WA/26/18/OUT

PLAN-022912

Proposal: Outline application with all matters for 6 No detached houses with detached garages. This application is a Departure from the Development Plan. Site: Former Lanes End House, Adjacent to West Walberton Lane & Arundel Lane, Walberton, BN18 0QS. WA/26/18/OUT

Southern Water MapGuide Browser

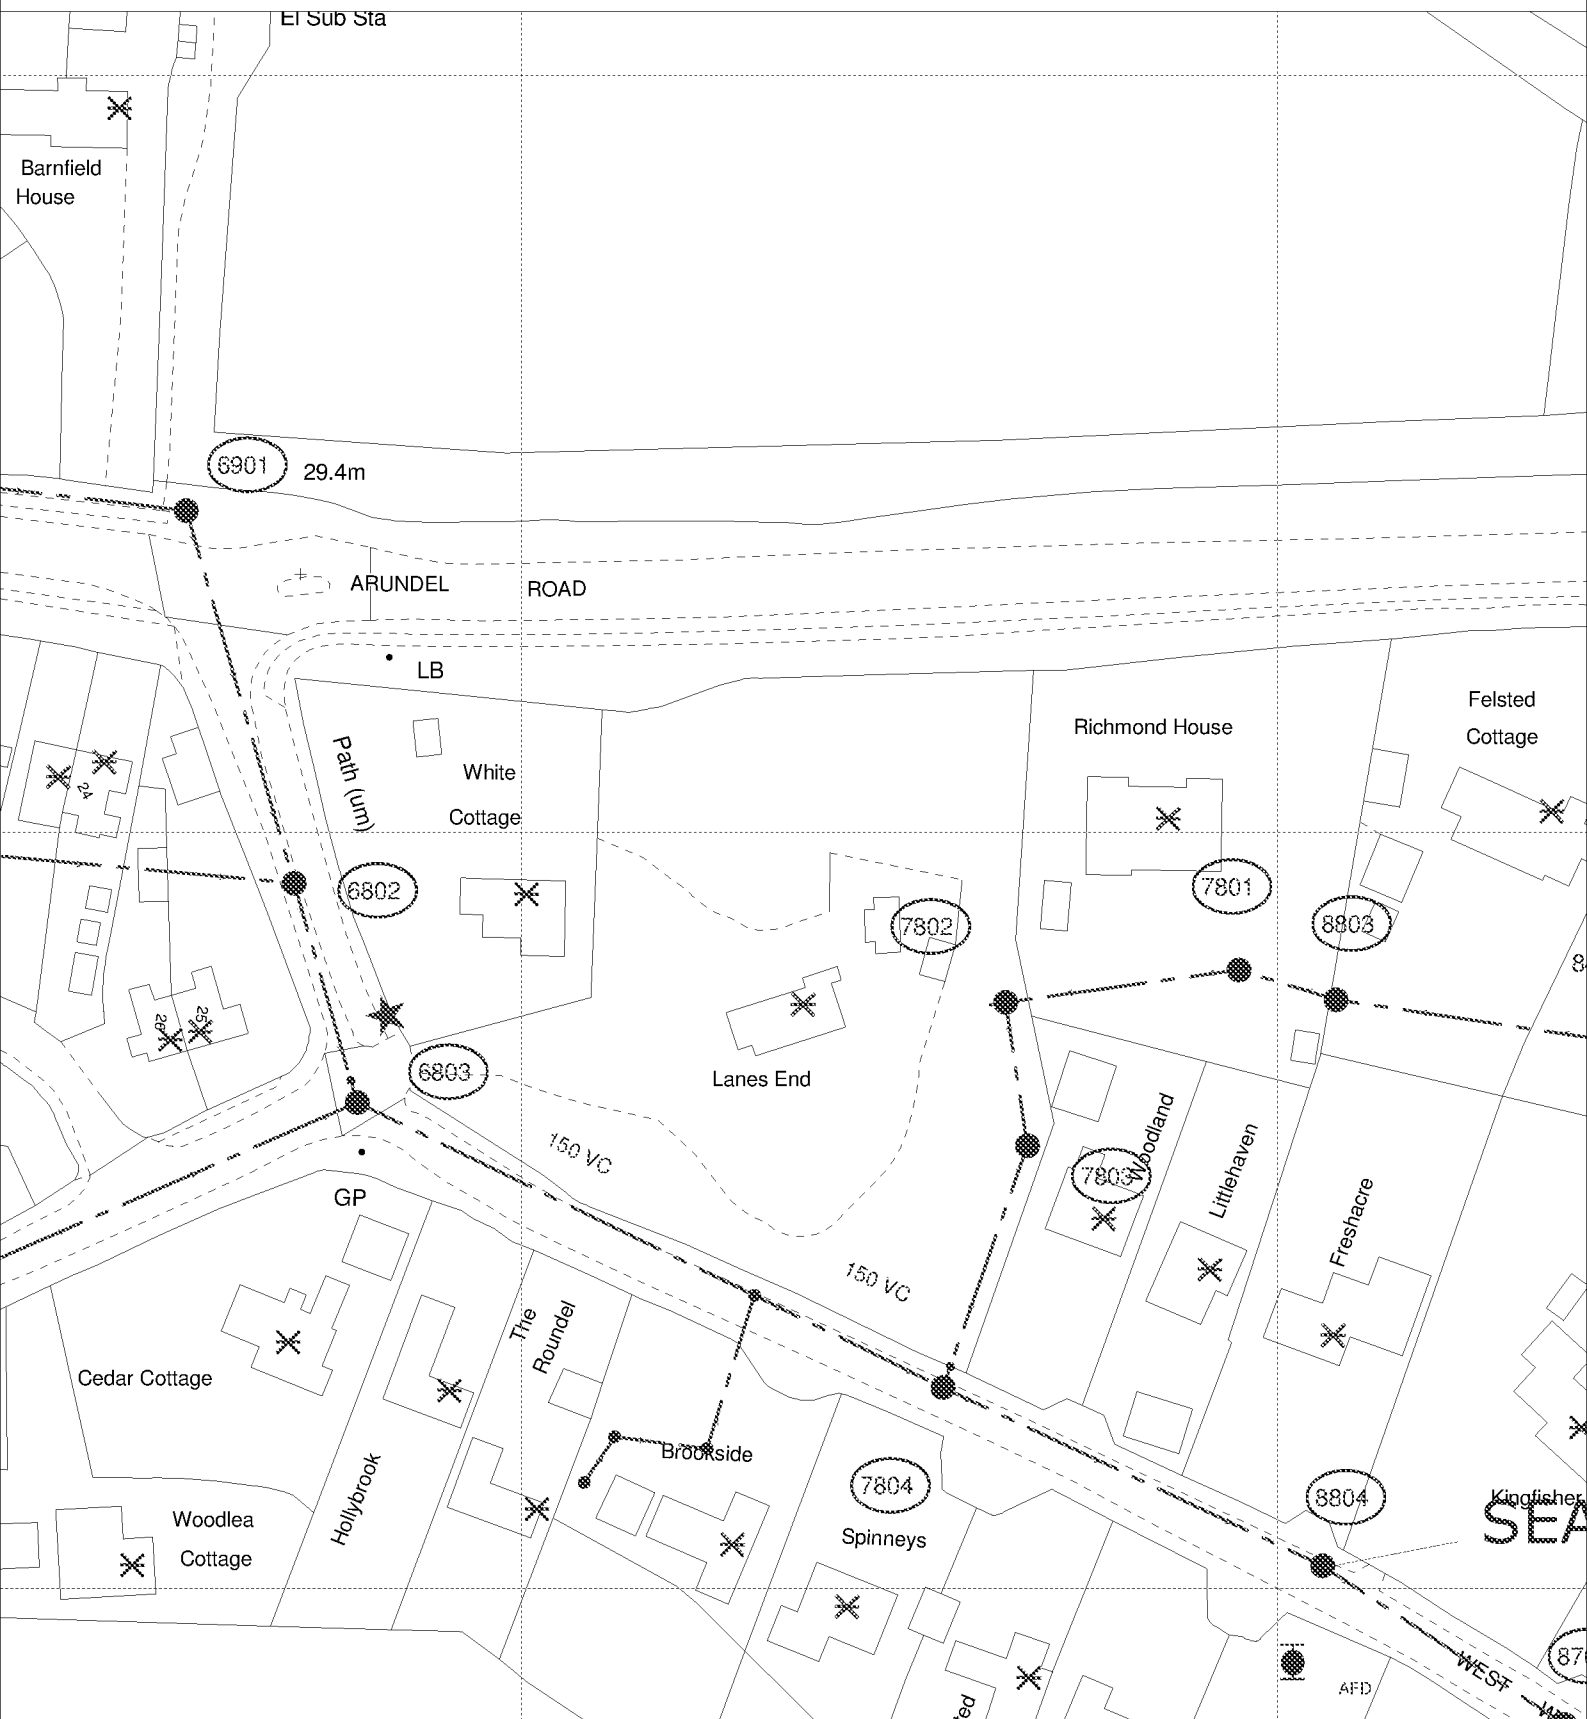
Please find attached a plan of the sewer records showing the approximate position of foul sewer crossing the site. The exact position of the foul sewers must be determined on site by the applicant before the layout of the proposed development is finalised.

It might be possible to divert the foul sewer, so long as this would result in no unacceptable loss of hydraulic capacity, and the work was carried out at the developer's expense to the satisfaction of Southern Water under the relevant statutory provisions.

1. The 150 mm diameter sewer requires a clearance of 3 metres either side of the sewer to protect it from construction works and allow for future access for maintenance.
2. No development or new tree planting should be located within 3 metres either side of the external edge of the public sewer
3. No new soakaways should be located within 5 metres of a public sewer.

4. All other existing infrastructure should be protected during the course of construction works.

Alternatively, the applicant may wish to amend the site layout, or combine a diversion with amendment of the site layout. If the applicant would prefer to advance these options, items (1) – (4) above also apply.

In order to divert drainage apparatus, Southern Water requests that if consent is granted, a condition is attached to the planning permission. For example “The developer must advise the local authority (in consultation with Southern Water) of the measures which will be undertaken to divert the public sewers, prior to the commencement of the development.”
